# Pre-Submission Publication Representation Form

Draft Revised Lambeth Local Plan Proposed Submission Version January 2020 (DRLLP PSV Jan 2020) and associated Proposed Changes to the Policies Map January 2020 (PCPM Jan 2020)
--

**DRAFT REVISED LAMBETH LOCAL PLAN  
FURTHER INFORMATION ON BEHALF OF ACOUSTIC GROUP LTD**

**Policy ED3 KEY INDUSTRIAL & BUSINESS AREAS / Proposals Map 2.12  
PROPOSED ACRE LANE KIBA**

Drawing: **1905007-TK06** Revision: -

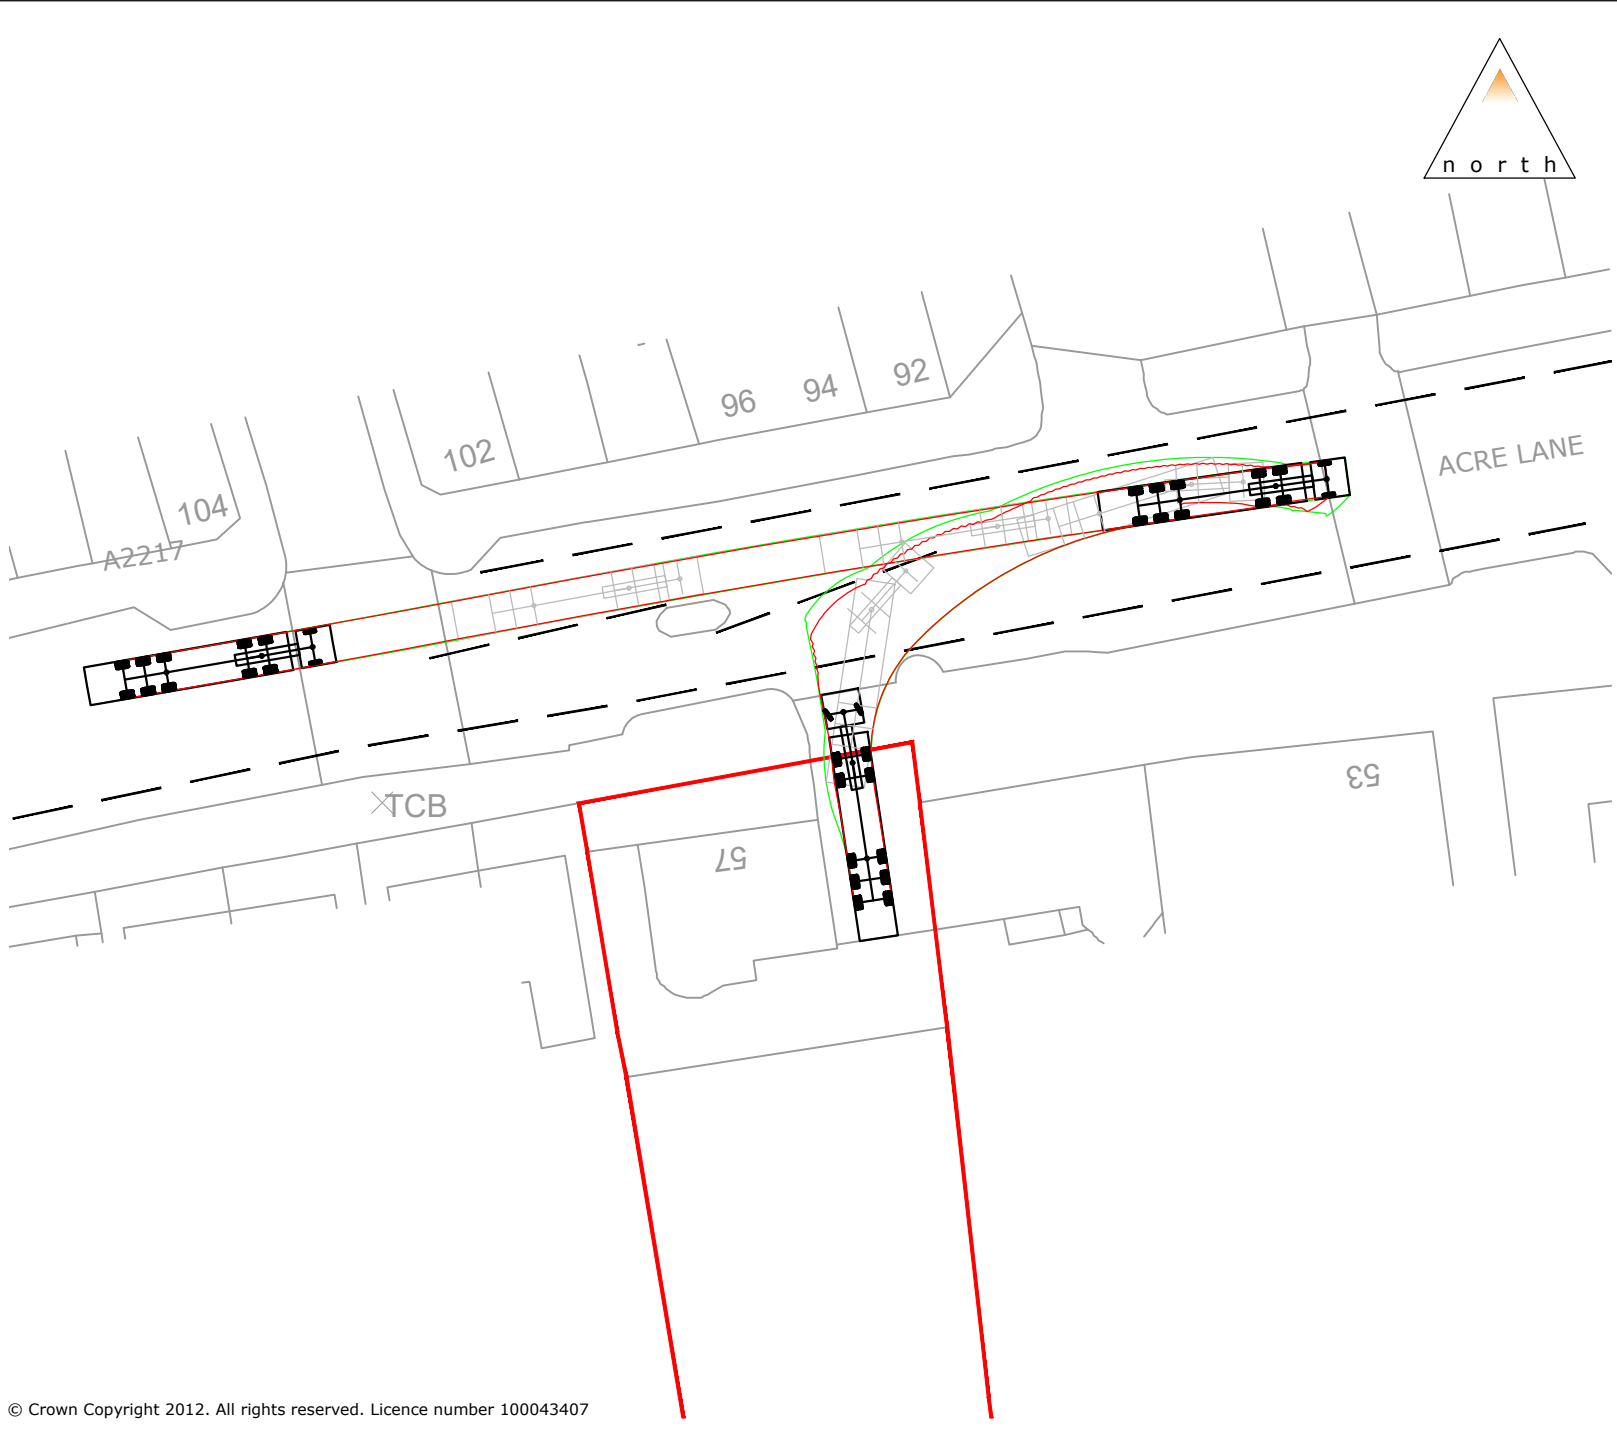
Due to the location of this traffic island, HGVs are unable to make left turns out of the site. This is an existing problem for the current operator of the site. HGVs therefore primarily access the site via the A23 to the east. A swept path analysis illustrating how large vehicles access the site is included at **Appendix A**.

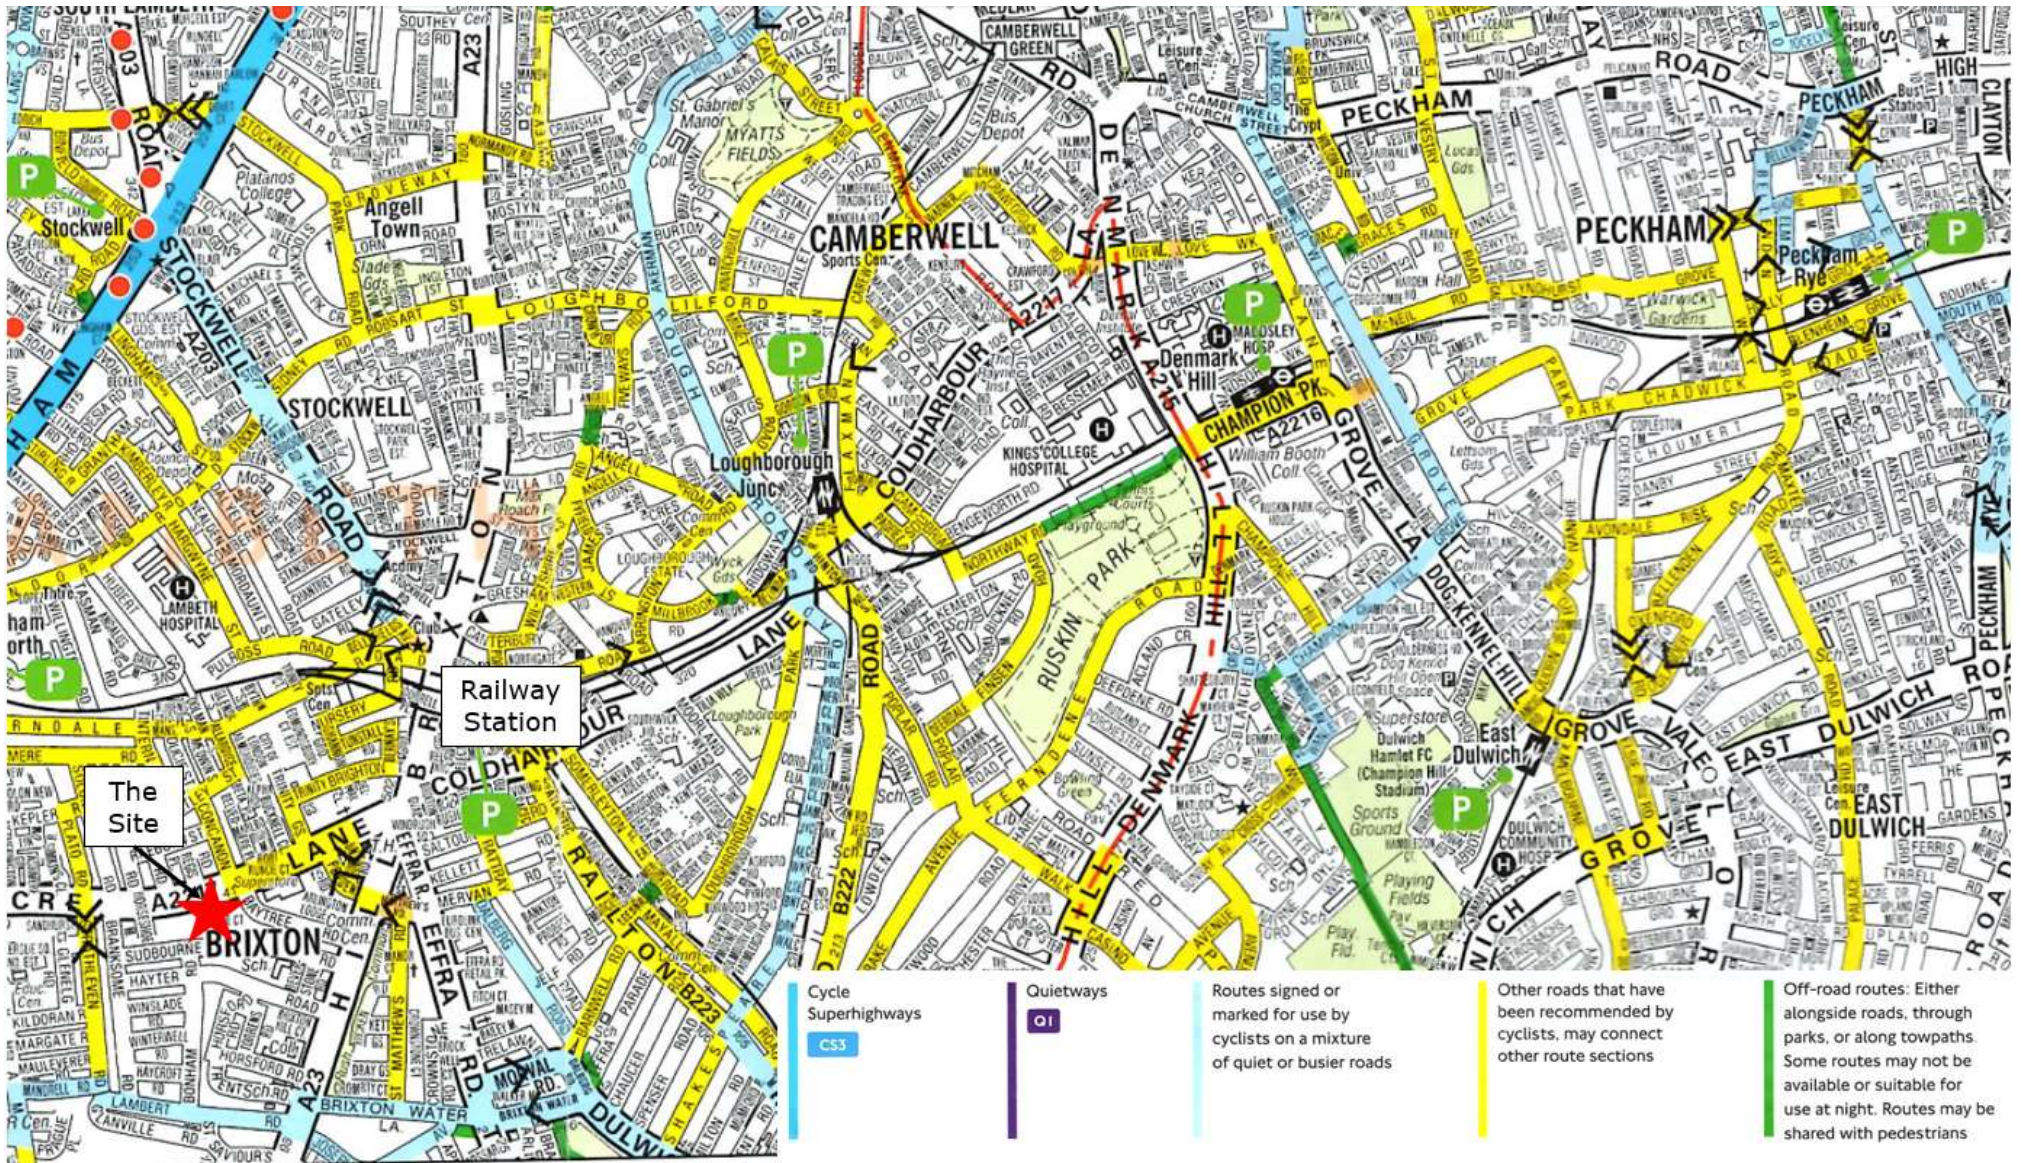
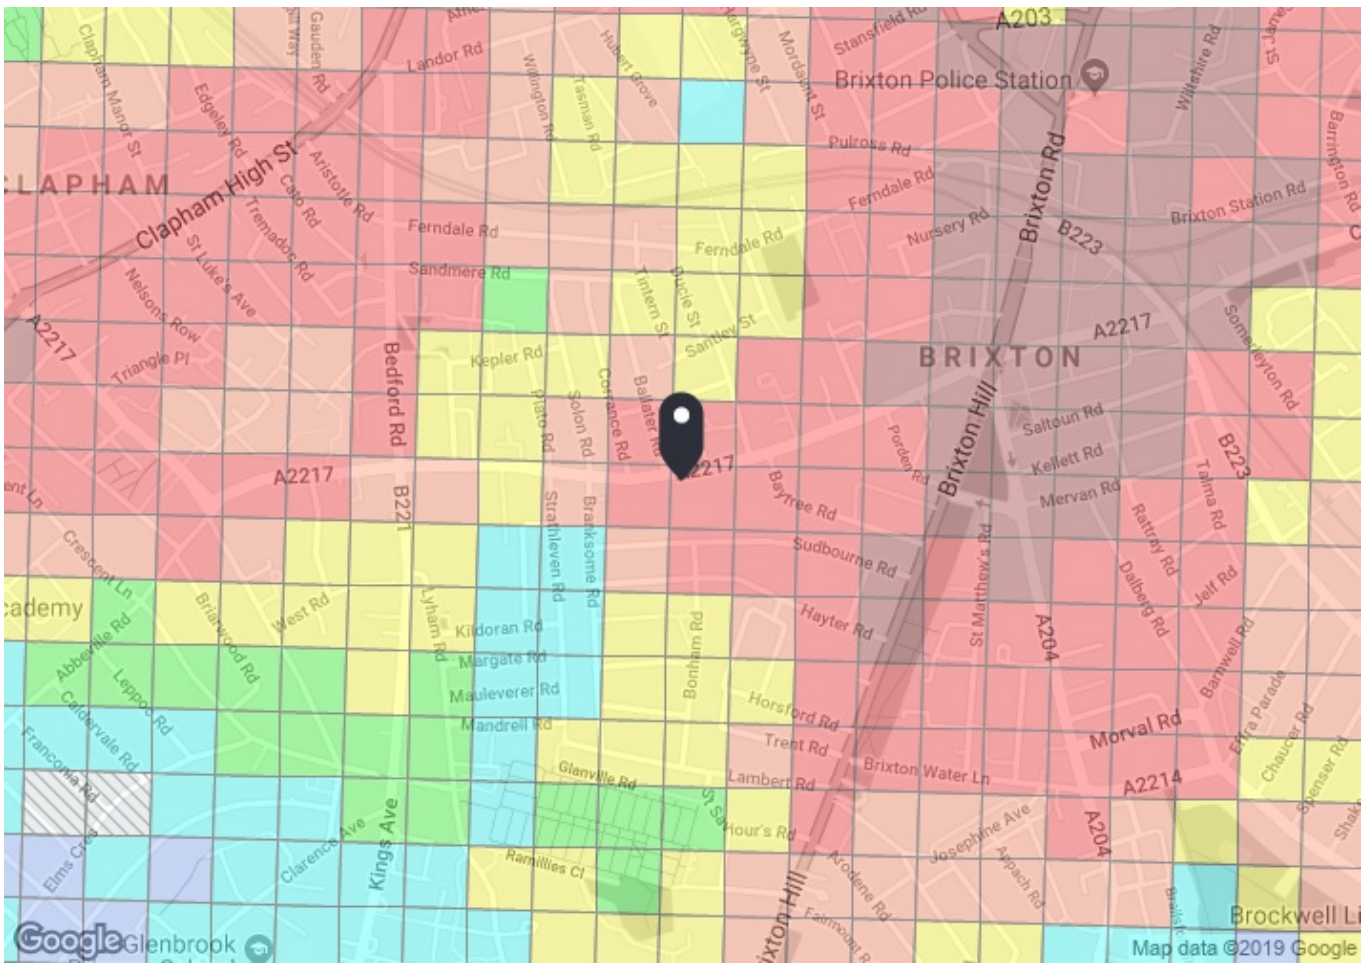
The Lambeth Waste Evidence Base (December 2019) - and Review of KIBAs for waste use - **does not distinguish between the different land ownerships** at Acre Lane. The '*access, congestion and road capacity*' consideration **makes no reference to the access limitations** of the 'parcel' at 57 Acre Lane - as **demonstrated in the technical evidence accompanying the representation** - and that would persist in the event of any re-use or redevelopment assuming the necessary retention of the listed building.

The Evidence Base consequently proceeds to suggest that the site is appropriate for 'repair and reuse', recycling and reprocessors' and 'collection and handling' uses **without the fundamental consideration** of site suitability in terms of access and site circulation requirements.

The '*potential opportunities, constraints and mitigation*' section similarly fails to identify the access (and circulation) limitations of 57 Acre Lane but identifies the main constraints to this site is (sic) the proximity of residential properties whose gardens back onto the site, the Grade II listed status of 55 and 57 Acre Lane, and the potential for neighbouring land at 47-51 Acre Lane to be used for the expansion of Sudbourne Primary School. The identification of such sensitive receptors is quite appropriate - as identified in earlier representations - but there is **no recognition at all of the significant constraint** of the access to 57 Acre Lane - as clearly identified and demonstrated in the technical evidence accompanying this representation - notwithstanding that the review of the site recognises that development needs to take into account the listed status of (55 and) 57 Acre Lane and that new development needs to be at the rear of the site.

The omission of such an important land use consideration in respect of the suitability of the site for waste uses - and the apparent absence of any recognition that **the site does not share a common access** with, and is of a different size and characteristics to, the remainder of the draft KIBA allocation - compounds the apparent omission of these same considerations in proposing other industrial uses within the draft KIBA designation.

The **Council's evidence base** is therefore flawed and **does not justify** the inclusion of the land at 57 Acre Lane within the proposed KIBA allocation and the limitations on the future use or development of the site that the policy would impose. The technical evidence submitted with this representation demonstrates the inclusion of the land for the proposed uses is not appropriate and not underpinned by a robust evidence base and justifies the exclusion of the site from the proposed KIBA.

The **change required** is to **remove** the land at 57 Acre Lane owned by the Acoustic Group Ltd from the draft KIBA designation.

Drawing: **1905007-TK02** Revision: -

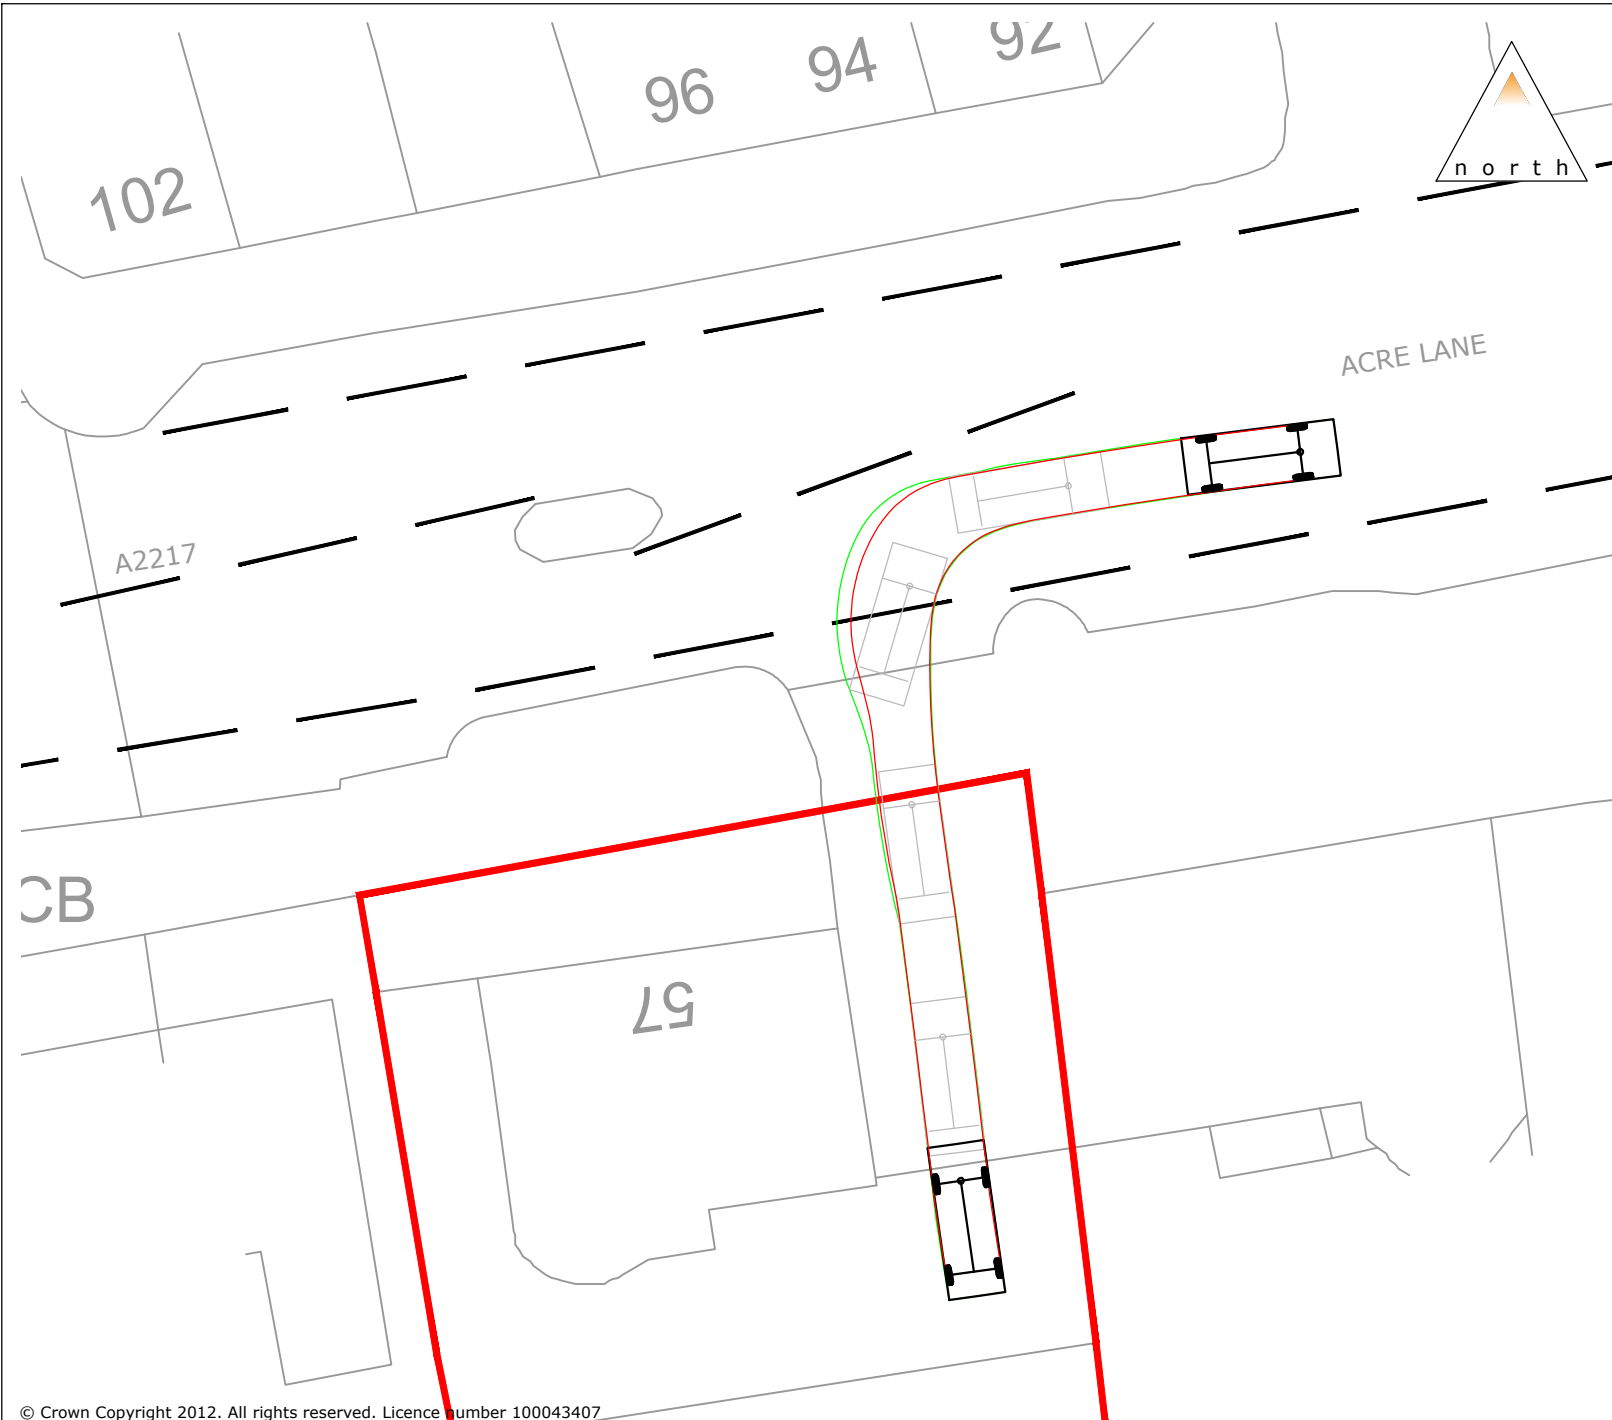
Any redevelopment of the rear of the site for the purposes identified in the draft KIBA designation would therefore need to provide loading/unloading facilities within the site. The swept path drawings included at **Appendix E** illustrate how this might be achieved. It is noted that whilst it is possible for a second or more articulated vehicle to enter the site whilst a first articulated lorry is parked there, the manoeuvre is extremely difficult and would only reasonably be undertaken under the supervision of a suitably qualified ‘banksman’. In any event, such an arrangement however would significantly limit the developable area of the site and the commercial viability of any necessary redevelopment.
